PRODUCT/PROCESS CHANGE NOTICE (PCN)

PCN #: TP1901-01 Date: February 8, 2019

PCN Type: Datasheet Correction

Figure 3. I²C Slave Read and Write Cycle Sequencing

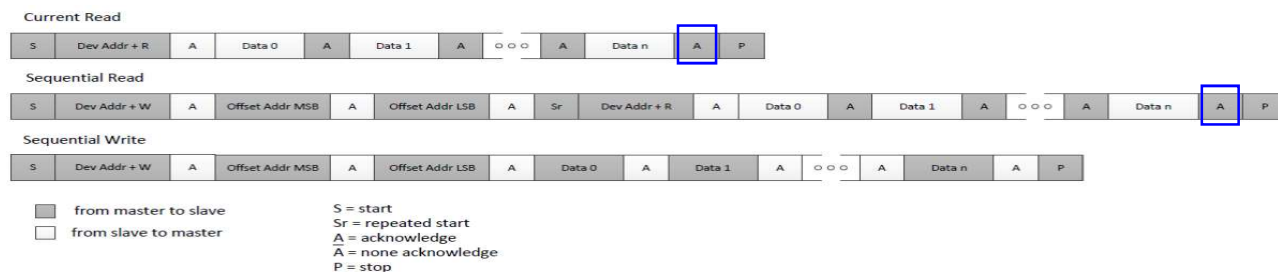
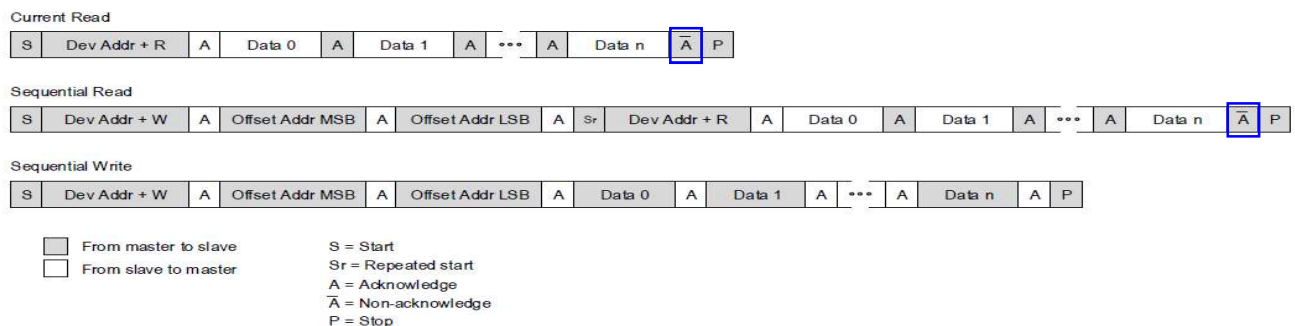
Detail of Change: Corrected the I²C read sequence diagrams to match I²C specification and actual device performance. Below is an example of the change. The figure # reference may vary per datasheet.
